Memo

TO: Chief Administrative Officer
SUBJECT: Point Ideal
DATE: March 5, 2021
FROM: Superintendent, Public Works and Engineering Services

PROJECT	POINT IDEAL
TITLE	TYPICAL SECTIONS & MISCELLANEOUS DETAILS

SCALE	AS SHOWN VERT. H/A
PROJECT NO.	01-095
ISSUED/PROJEN	4/8
APPROVING AUTHORITY FILE NO.	
DRAWING NO.	01-095-C08

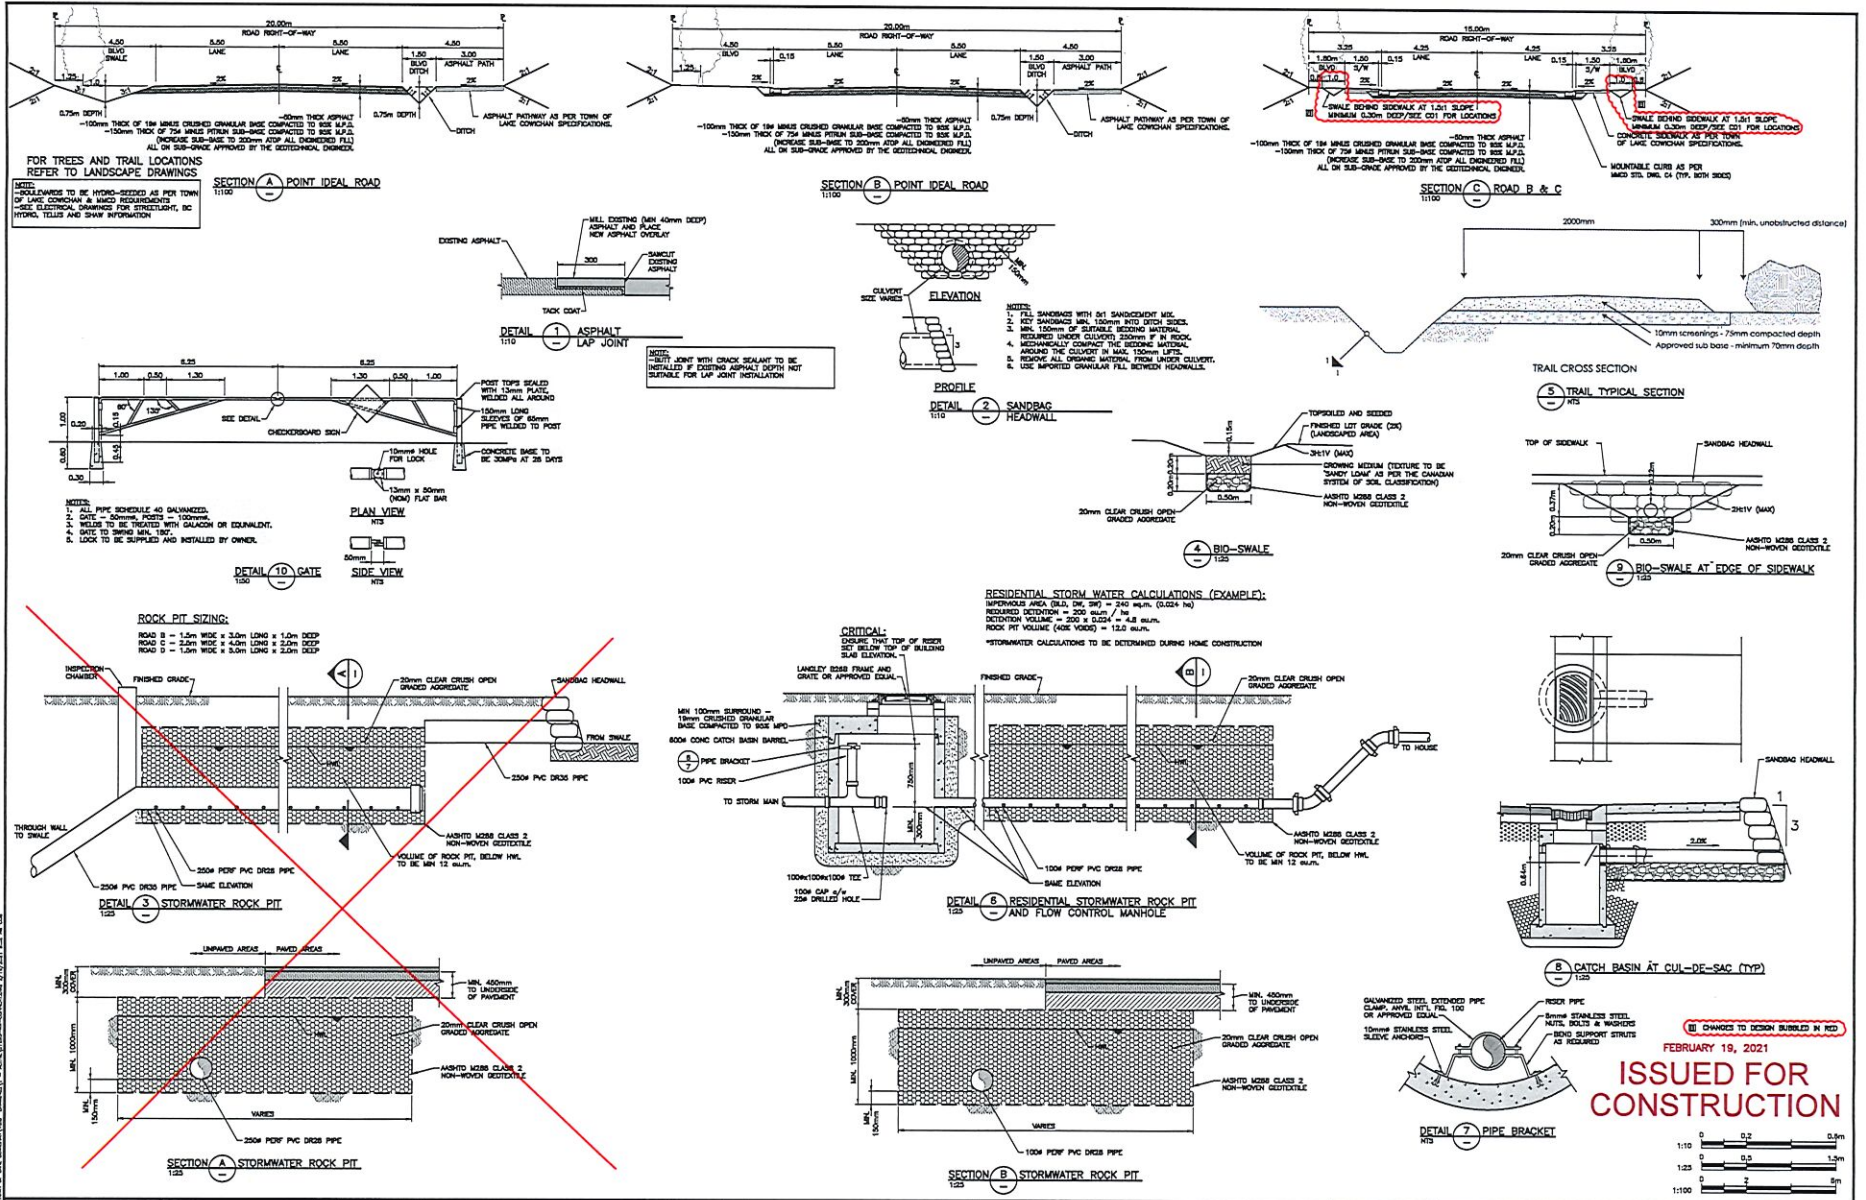
Note: The Town does not have a record of the final drawings that were issued for construction by the developer. They were partially forwarded to us on February 22nd, 2021 – see attachments.
